CITY OF ALBUQUERQUE

RE: **Whataburger
Grading and Drainage Plan
Engineer's Stamp Date 2-18-2015 (File: K10-D001B)**

RE: **Whataburger
Grading Plan
Engineer's Stamp Date 2-18-2015 (File: K10-D001B)**

WHATABURGER
COORS AND CENTRAL
GRADING AND
DRAINAGE PLAN

ENGINEER'S SEAL RONALD R. BOHANNAN P.E. #7866	WHATABURGER COORS AND CENTRAL STORMCHAMBER STORAGE SYSTEM	DRAWN BY BJF DATE 02/18/15 2014075_GRB
	TERRA WEST, LLC 5571 MIDWAY PARK PLACE NE ALBUQUERQUE, NM 87109 (505) 858-3100 www.tierrowestllc.com	SHEET # C3 JOB # 2014075

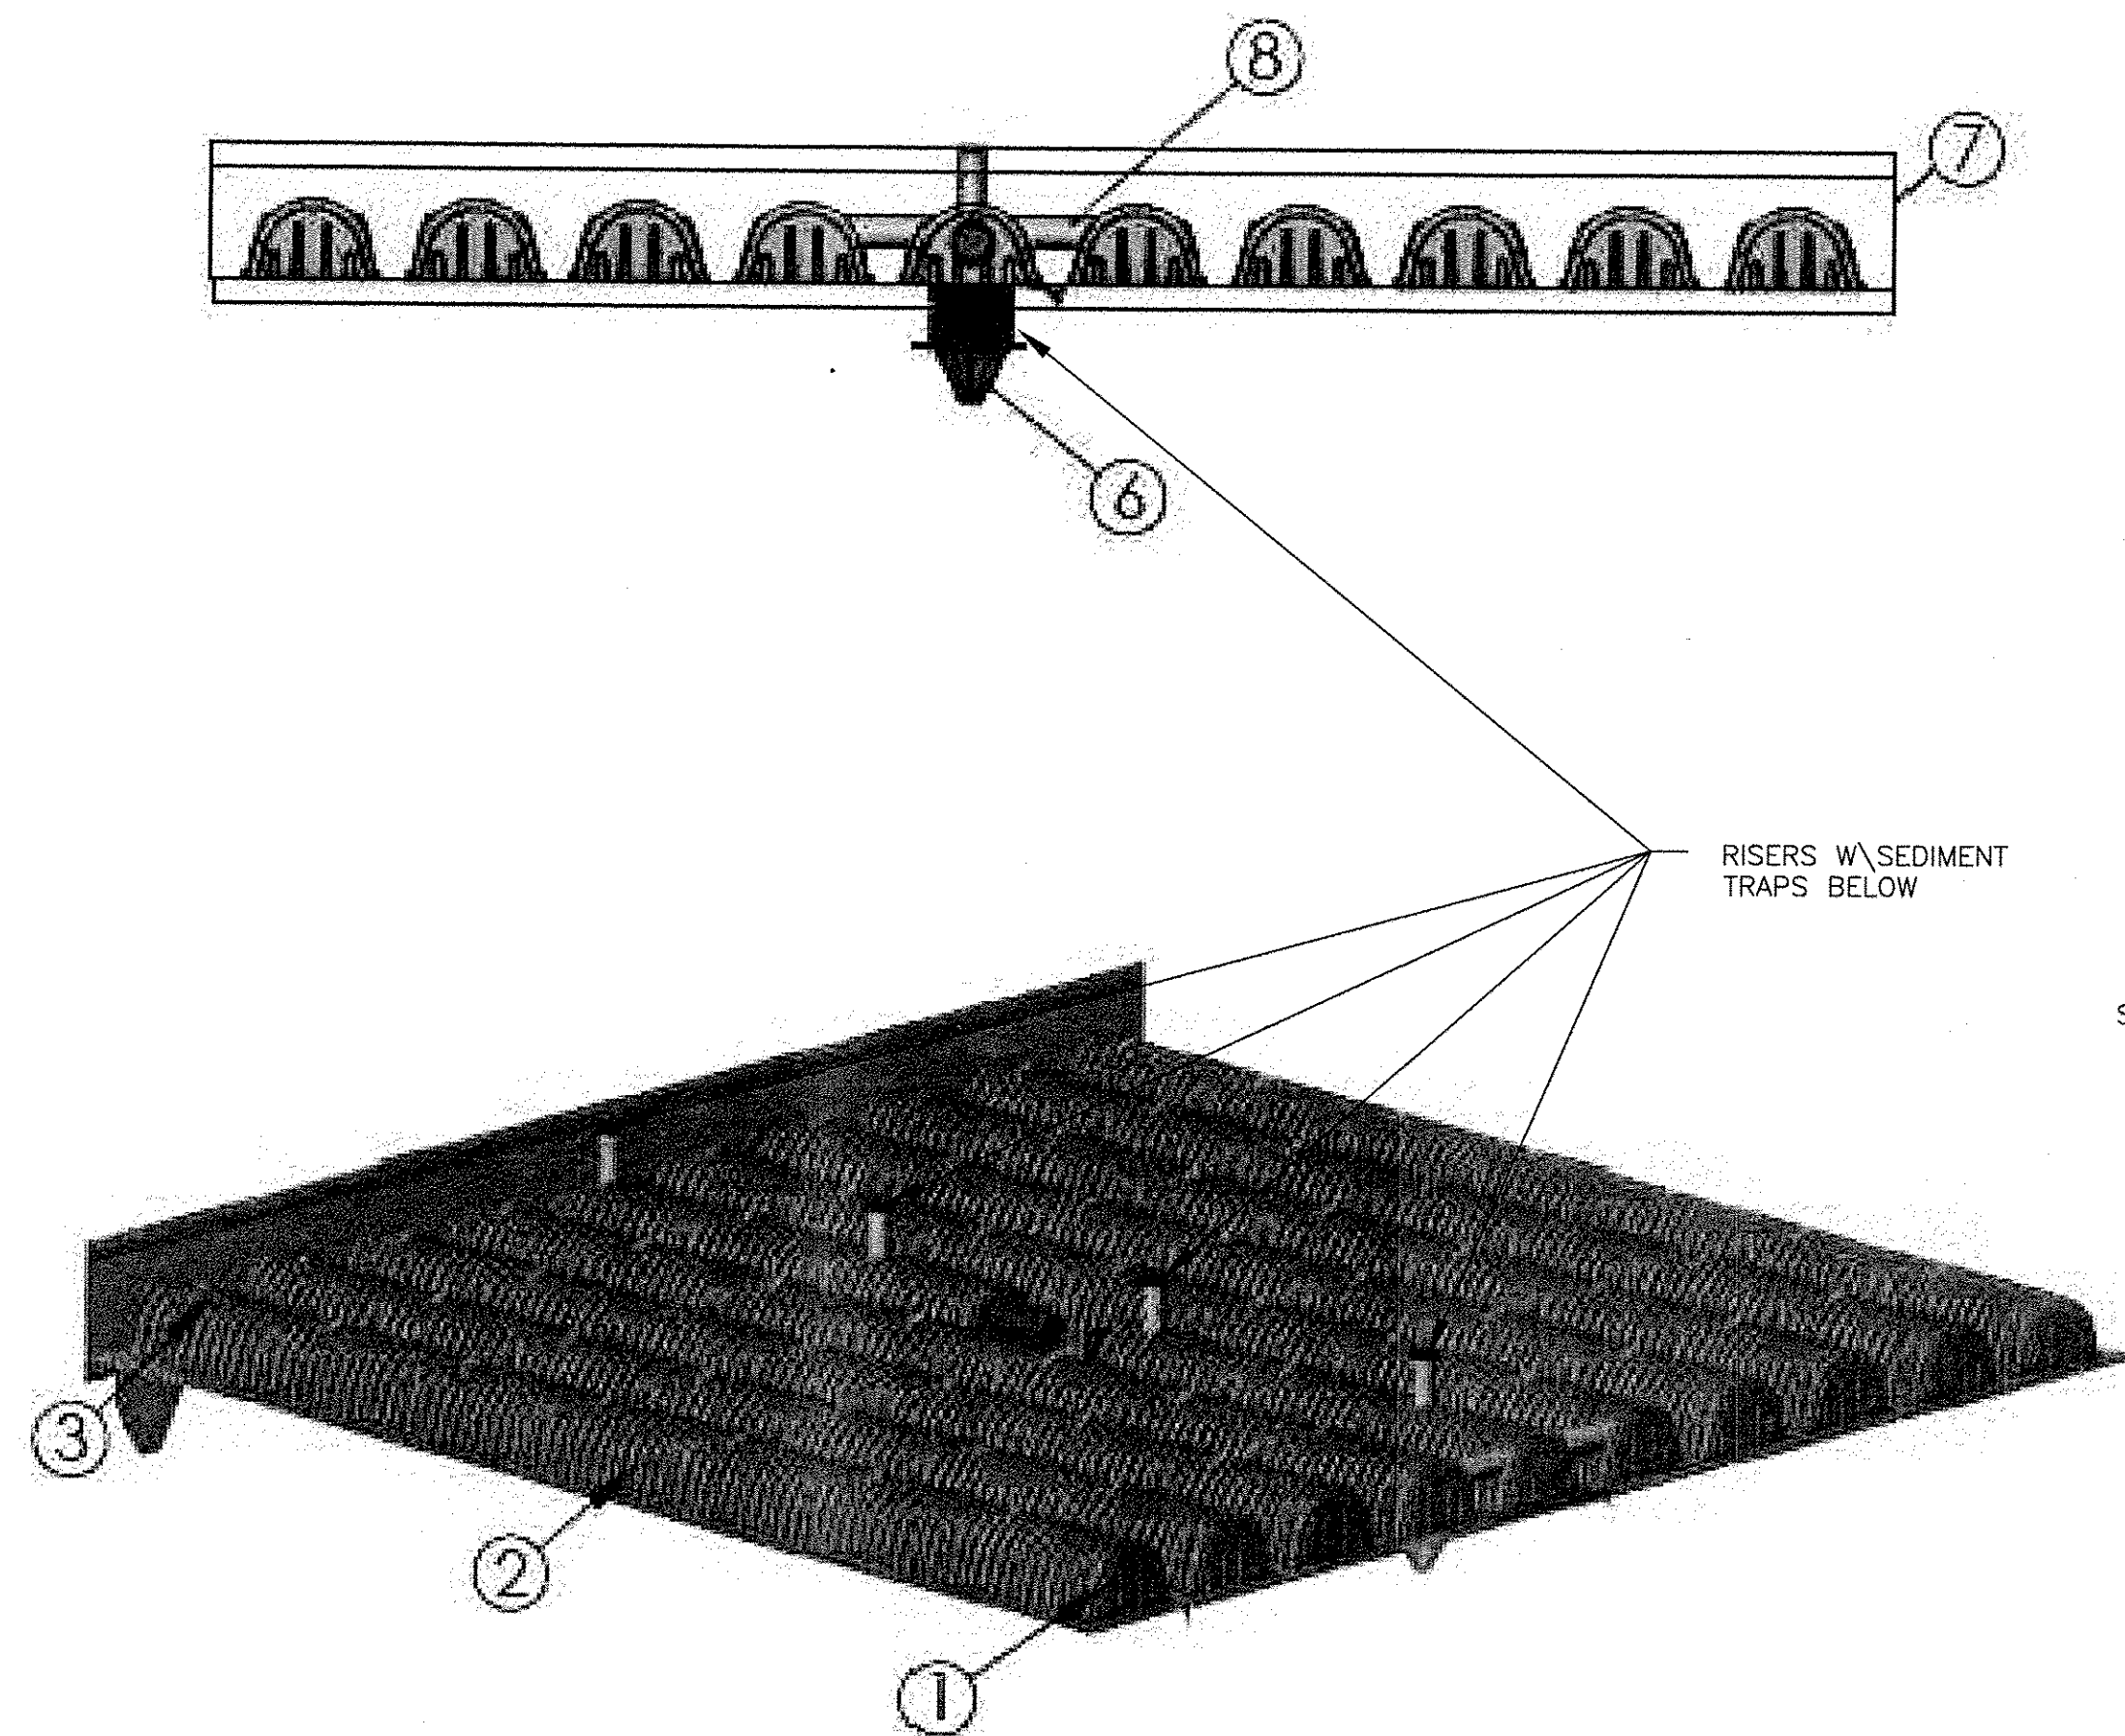
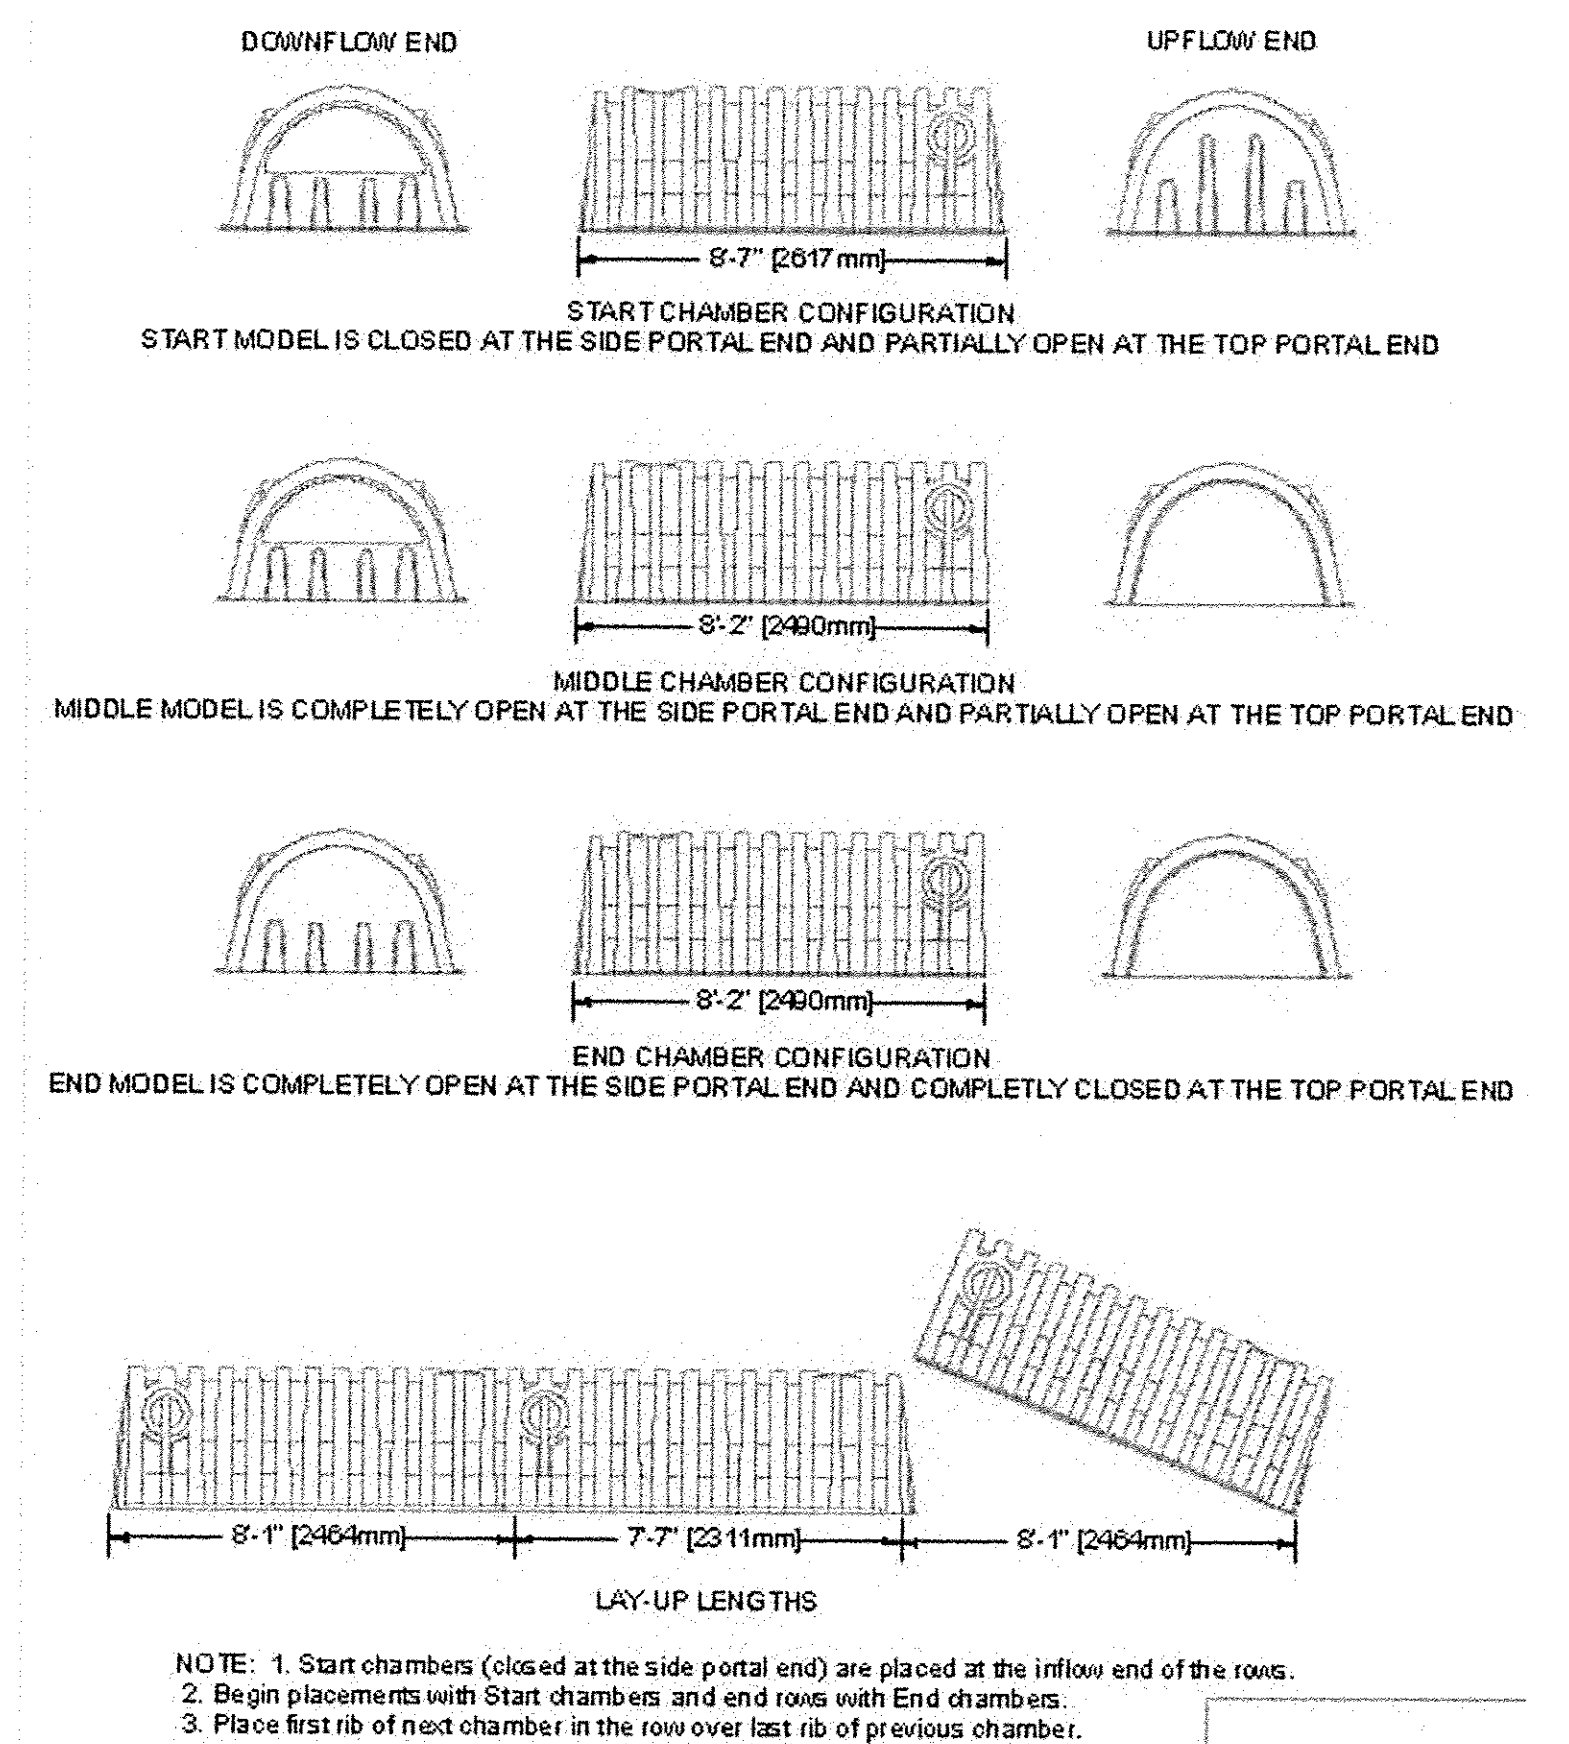
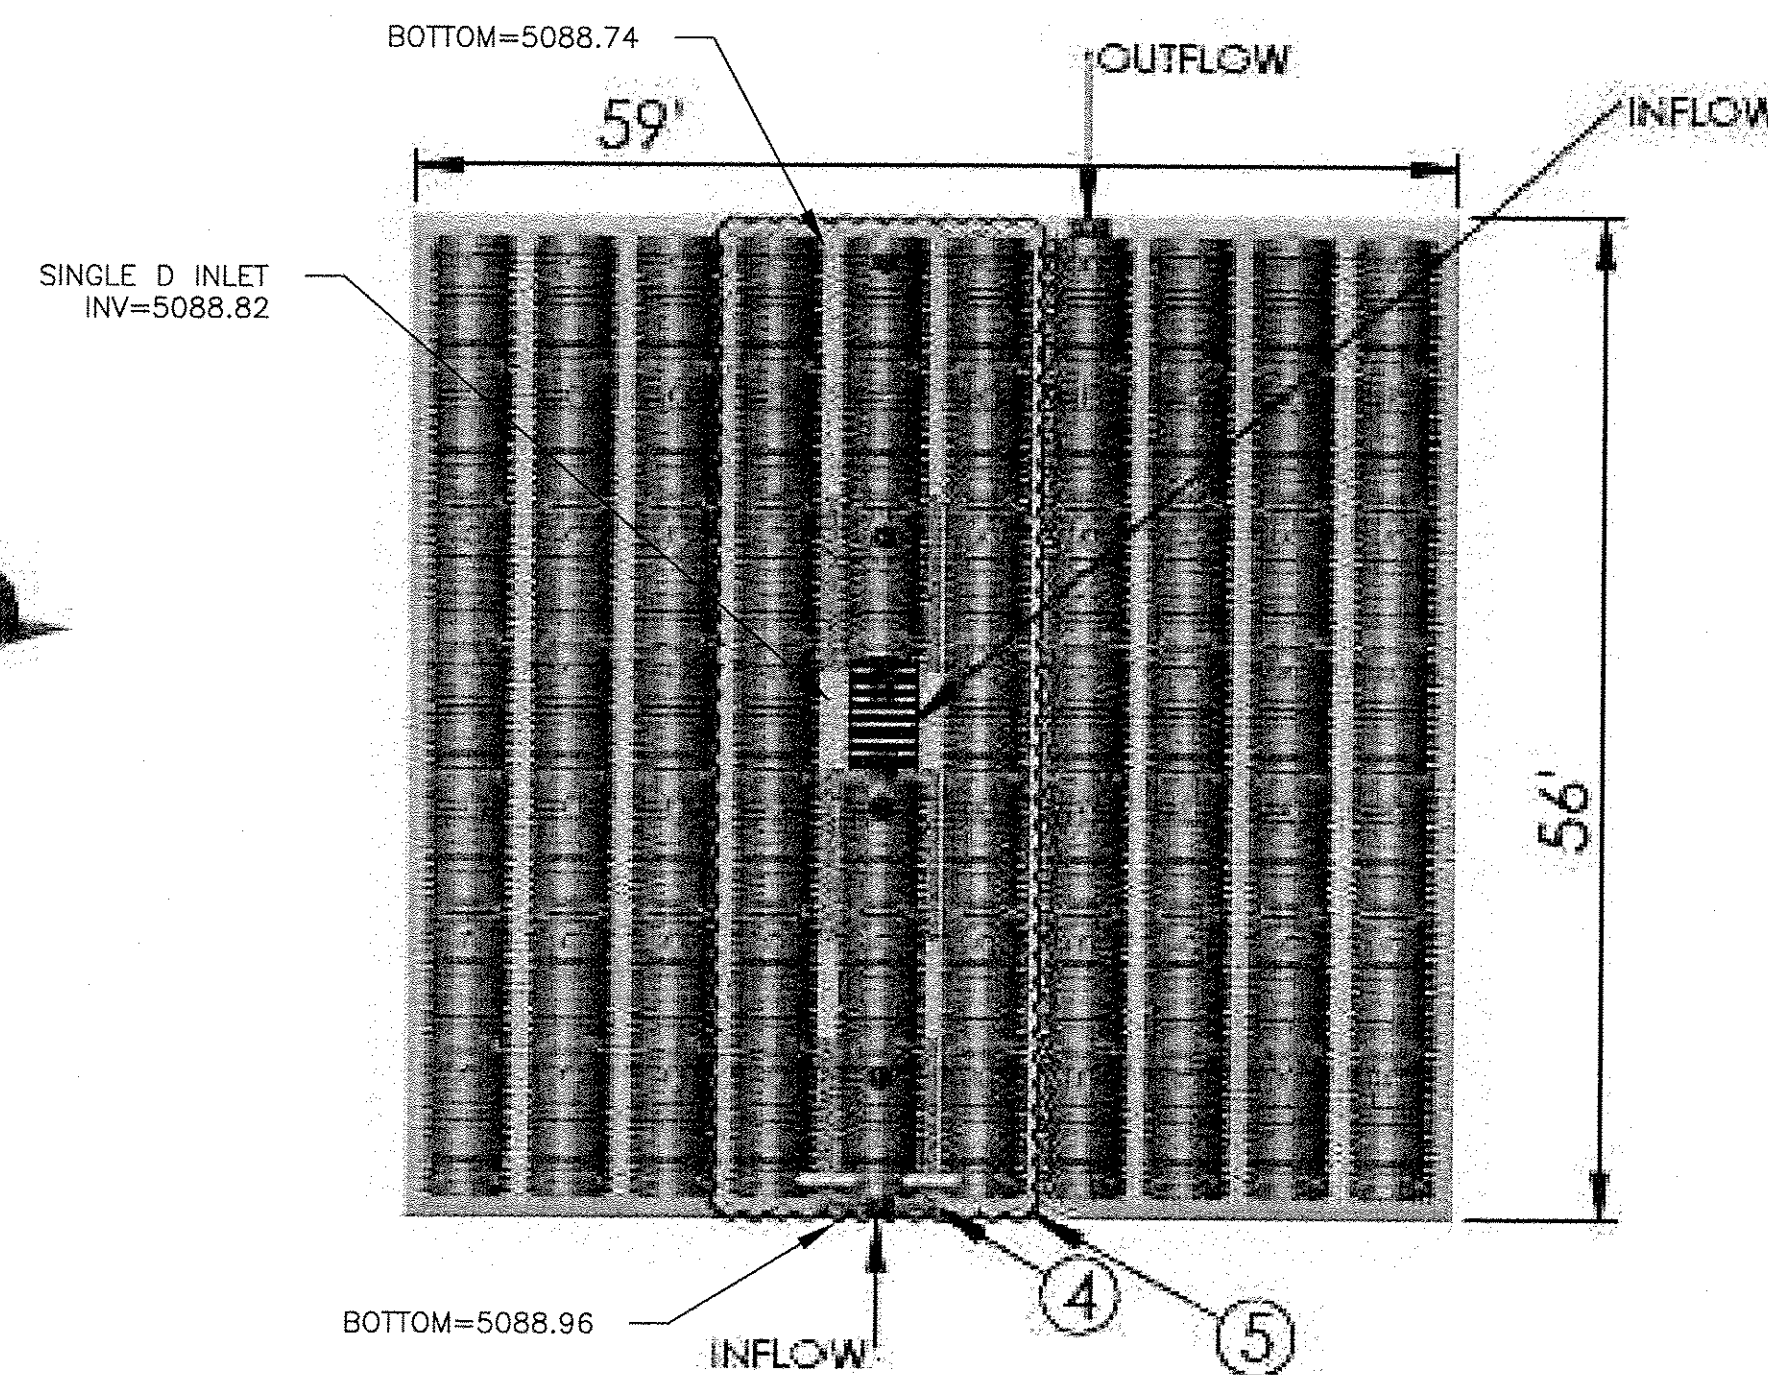
- 9) The number of chambers shown on the "Basin Map and Calculations" sheet is 75. This needs to be called out on the plan view detail on the "Stormchamber Storage System" sheet to make sure the right number of stormchambers will be installed. Also, please provide a legible table showing the layout dimensions for the stormchambers.
